15TH JUNE 1891, No. 1612 W., PUBLIC WORKS.

GOVERNMENT OF MADRAS.
PUBLIC WORKS DEPARTMENT.

District Munsif's Court-house
at Chidambaram, South Arcot
District

Revised estimate, amounting to Rs. 15,300,
for constructing a —, sanctioned.

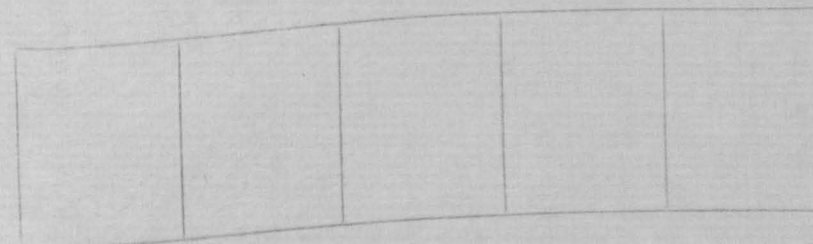
I consider Horbury's patent privies for natives, as put up by this municipality near the market, with well-drained good cement floor, very suitable. It is sufficiently roomy, well ventilated, occupies the least possible space, and, being entirely of iron, perfectly free from noxious absorption and consequently very sanitary. There is one little improvement on the plan that I think will greatly add to its privacy. The entrances to the privies should be better screened off thus:

The wave lines show the proposed prolongation of the screen-walls to secure better privacy.
20th June 1888.
